OPW Oifig na
nOibreacha Poiblí
Office of Public Works

Flood Map Update

MR021 Avoca

Version 2.0
March 2026

Figure 1: The modelled watercourse alignment (red) and the actual watercourse alignment (green) in Avoca, Co. Wicklow.

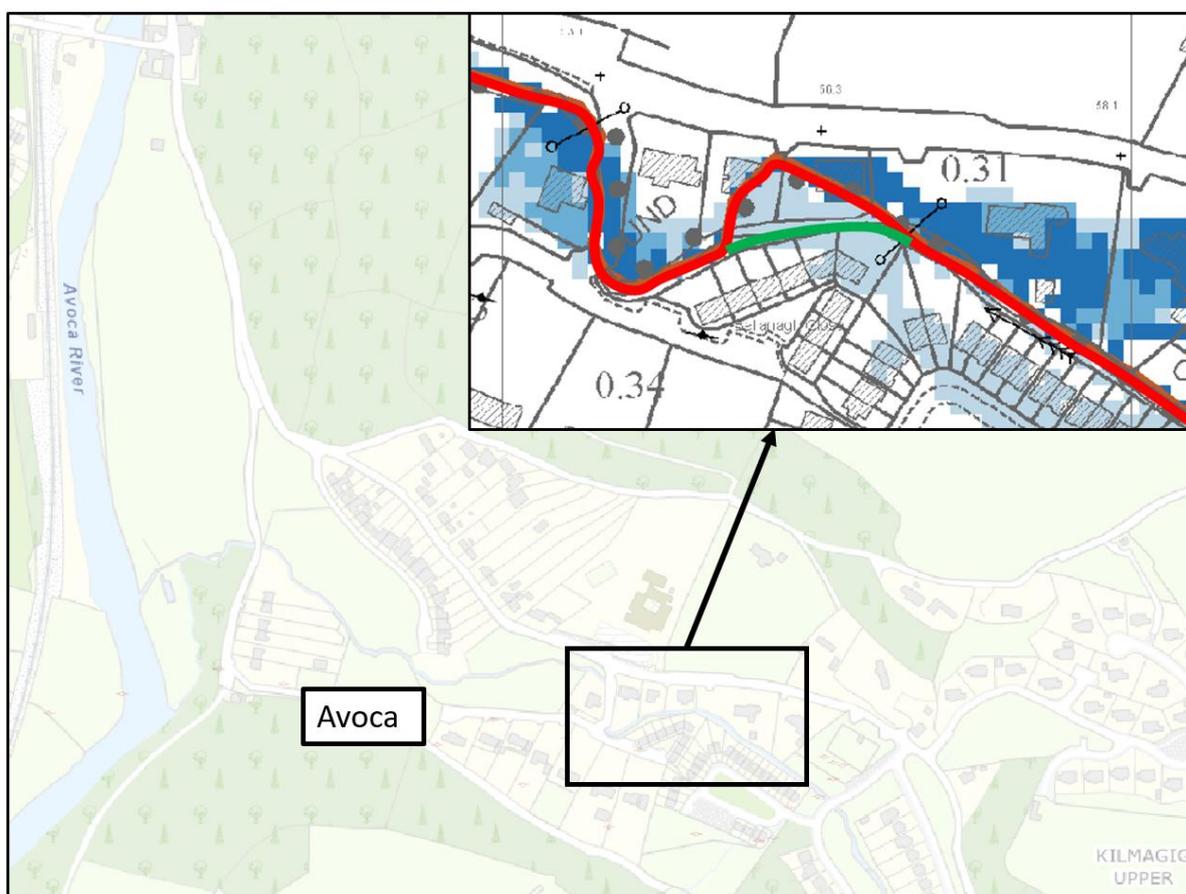
A Flood Map Review Request was received by the OPW which indicated a potential anomaly in the flood mapping regarding the alignment of the Avoca Trib3 watercourse. Figure 1 shows the location of the misaligned watercourse. As shown, this tributary of the Avoca River is modelled (red) as passing through the footprint of two houses rather than along the actual alignment of the river (green).

The Flood Map Review Request also queried the overland flood route that results in the same houses shown to be at risk, noting it was unlikely to occur in reality given the ground levels and streetscape features present.

An initial assessment was carried out of the items raised in the request. It was determined that the alignment of the Avoca Trib3 was incorrectly represented in the model. The tributary passes through the footprint of two houses rather than along the actual alignment of the

watercourse. The survey data for the CFRAM study contained the misalignment, which in turn was used to inform the hydraulic model.

The OPW will only carry out a Map Update when the information provided supports one of the criteria described in Section 1. The channel misalignment identified satisfies the criteria of a survey error. An update of the flood maps is warranted in this case.

Figure 2: Site visit issues identified

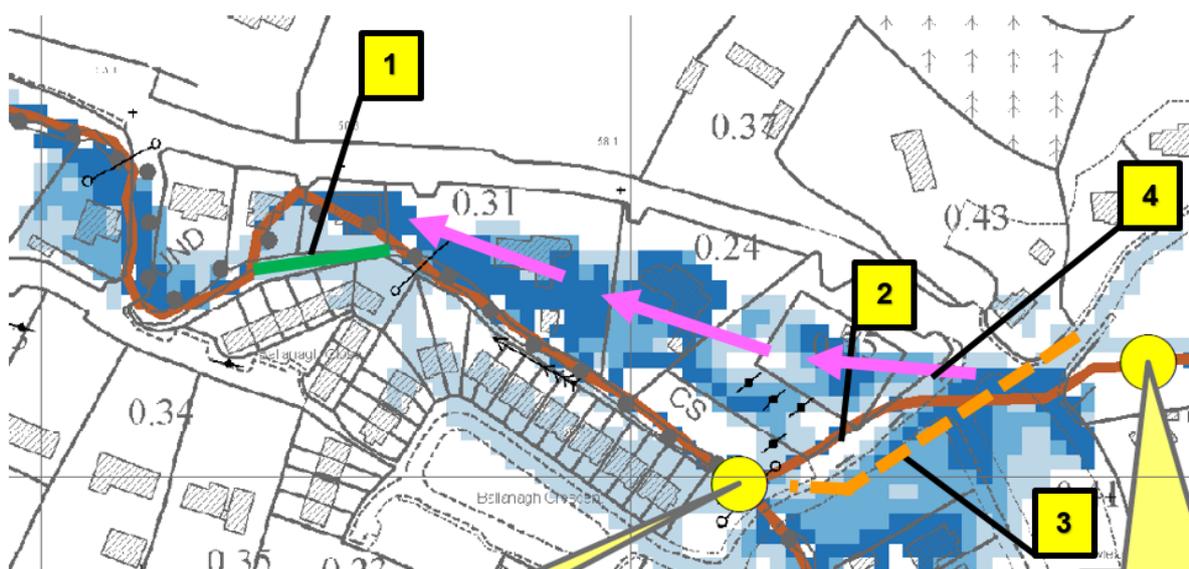
To inform the Map Update a review of the survey data, flood maps, and the relevant CFRAM study reports was undertaken. A site visit was also carried out to identify any other issues that may be present and to verify information on the ground. The findings are listed below, and identified by number in Figure 2.

1. The alignment of the Avoca Trib3 was incorrectly recorded in the survey data and therefore incorrectly modelled in the CFRAM study.
2. The final modelled section of the Avoca Trib4 is culverted in a 450mm pipe from a headwall just upstream of the main road (L2180), to where it discharges into the Avoca Trib3. This culvert was visibly blocked to a significant extent at the upstream face by debris, with limited capacity evident.

3. A new 600mm diameter pipe / culvert (orange) has been installed since completion of the CFRAM study by the Local Authority on Avoca Trib4. This runs from the headwall adjacent to the 450mm inlet, to the Avoca Trib3 at a point upstream of the existing 450mm outlet.

4. After inspection, it was considered possible that the overland flow path illustrated in the Flood Maps (identified by magenta arrows) may not represent the actual flow path, owing to the presence of a raised verge and kerb adjacent to the estate road.

- Correct the alignment of the Avoca Trib3
- Retain the existing 450mm culvert in the model and apply a 100% blockage
- Survey the new 600mm diameter culvert and include it in the hydraulic model
- Capture additional survey data to better represent the overland flow path identified by the Map Review Request and incorporate it into the model
- Utilise the hydrological flows from the original CFRAM study to undertake the hydraulic model runs
- Produce updated Flood Maps and associated data from the hydraulic modelling results

Figure 3: Items surveyed

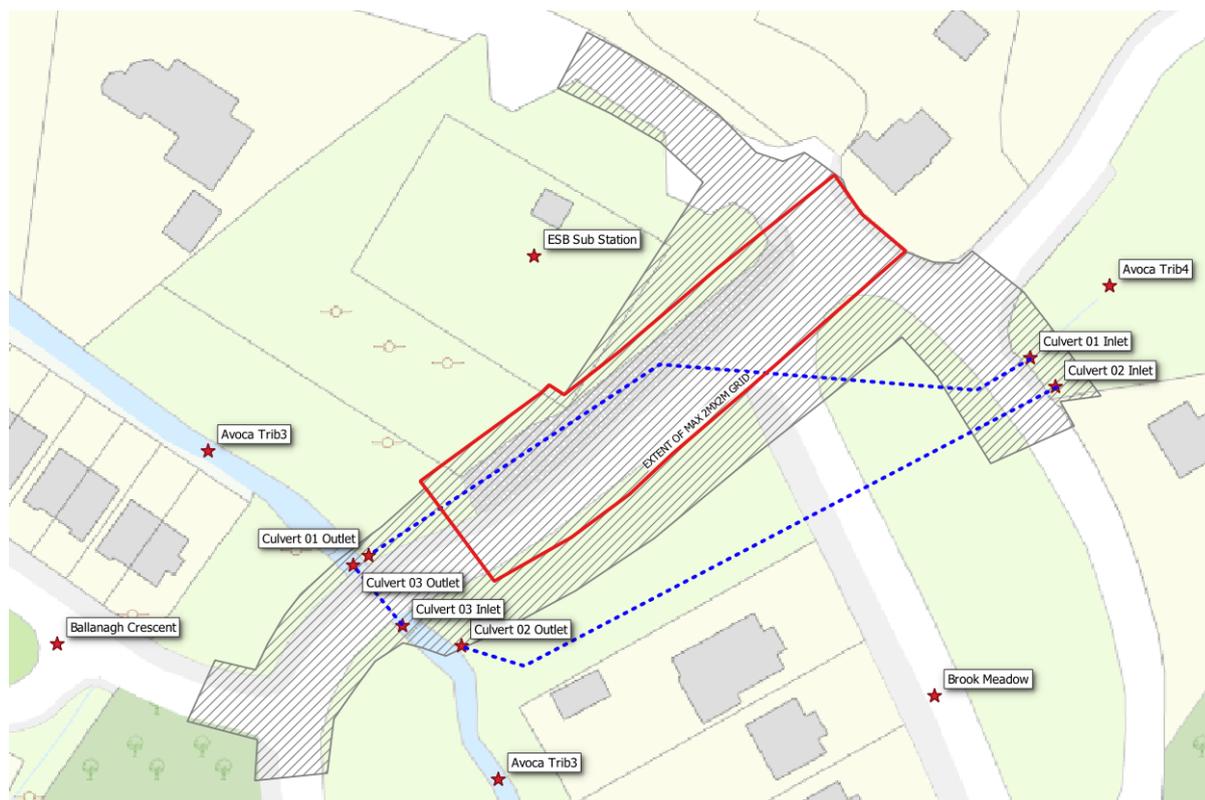
Additional survey data was captured in the areas identified in Figure 3 to improve the accuracy of the mapping. This included:

- A general topographical survey of the area from the upstream end of the new culvert, across the overland flow route (identified by grey cross hatching)
- A detailed topographical survey of the critical area to verify the actual flood path (red outline)
- Invert levels for the upstream and downstream faces of the 450mm Culvert (Culvert 1) and 600mm Culvert (Culvert 2)
- A cross section for the upstream face and headwalls of Culvert 1 and Culvert 2

Figure 4: Comparison of original CFRAM extents and the updated flood extents

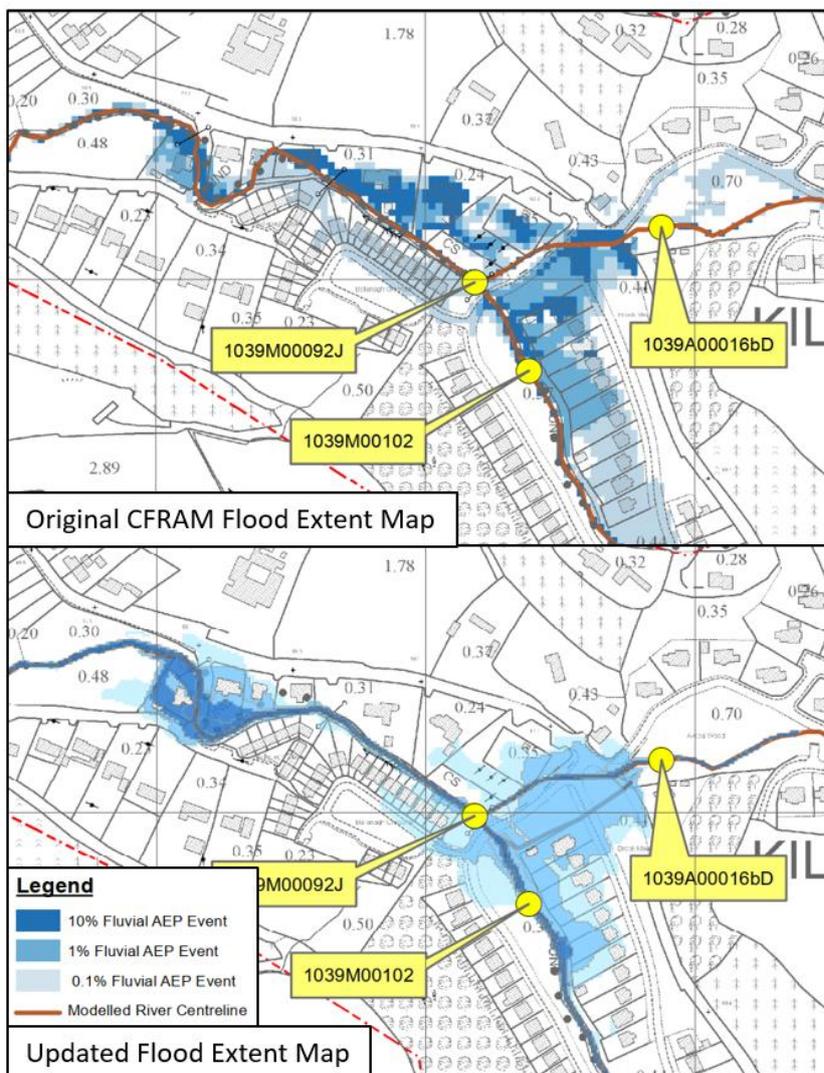
The adjustments to the model have resulted in changes to the flood extents locally, particularly the overland flow route from the culvert inlet across the ESB substation site and several properties to the west (i.e. downstream of node 1039M00092J). Figure 4 shows a comparison between the original CFRAM flood extents and the updated flood extent map.

One of the most notable differences is the decrease in the 10% AEP flood extent across the map update area. The increased resolution of the model relative to the CFRAM Study specification appears to have had the biggest impact on the mapping, producing cleaner flood extents when compared to the original flood maps.

While this map update has resulted in significant changes to the flood extents, it incorporates a larger culvert on Trib4 not included in the original model, as well as utilising higher resolution survey data than was required under the CFRAM. It is likely that these changes alone have had a more significant impact on the flood extents than the correction to the Trib3 alignment. Note that mapping produced under the CFRAM Study was at a larger 'Community Scale' than this Map Update and at a particular point in time.
